RE: Alamosa Community Center Expansion 6900 Gonzales Rd SW Grading and Drainage Plan

> Engineer's Stamp Date: 1/10/20 Hydrology File: L10D013

Based on the submittal received on 1/13/20, the Grading and Drainage Plan cannot be approved until the following corrections are made:

SITE PLAN
1/8" = 1'-0"

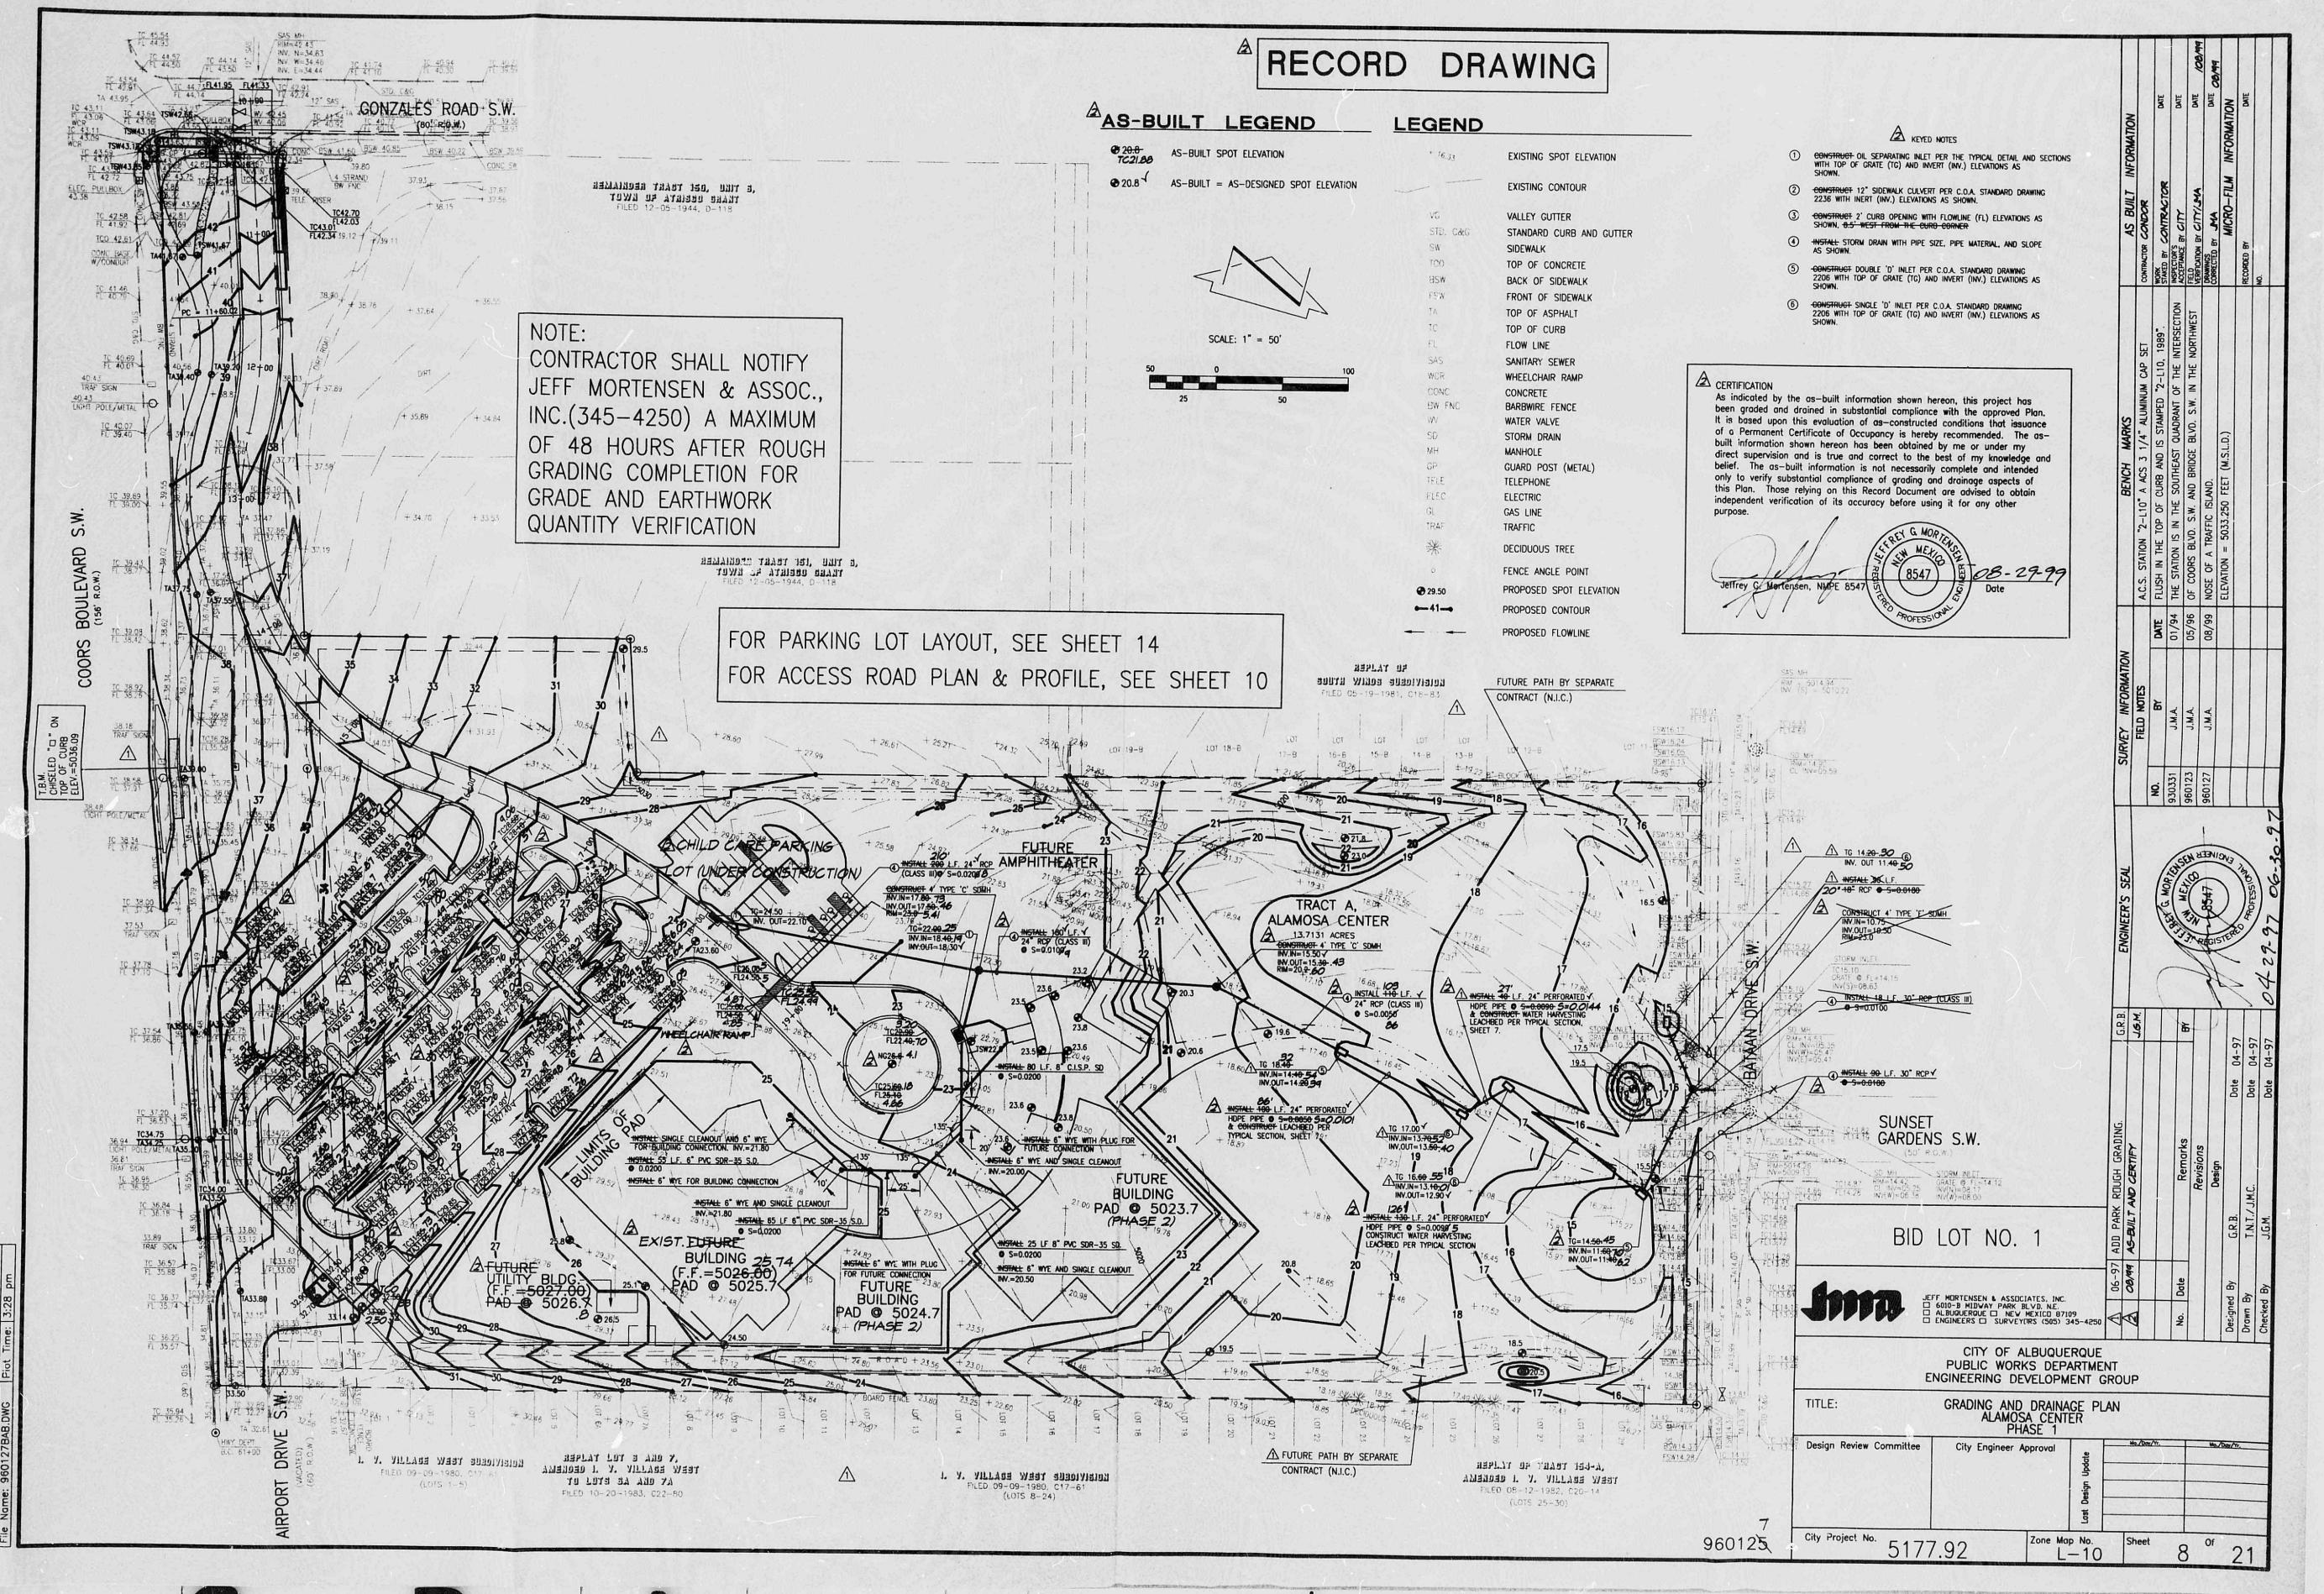
- 1. A grading plan needs to be prepared, per the DPM Ch. 22.7, *Grading Plan Checklist*. Key items missing from viewport A1 and the narrative include:
 - Legend see D.P.M. Manual, Volume 2, Tables 27.3a 27.3d for recommended standard symbols

- Benchmark location, description and elevation
- Legal Description
- Proposed spot elevations, including finished floor

- Flow lines (and roof drainage) defined by arrows and spot elevations with NAVD 88 designation.
- Details (as needed) of ponds, inverts, rundowns, curb cuts, water blocks, emergency spillways, retaining walls, pond outlets, safety fences, slopes, and all other significant drainage structures with contours, cross-sections and spot elevations. All cross-sections must be drawn to a standard engineering scale and adequately dimensioned.

- Existing peak runoff (see section V or your drainage narrative).
- 2. The drawing needs to be scaled to a common Engineers Scale such as 1:20 or 1:30 (viewport A1 is shown in Architect Scale).
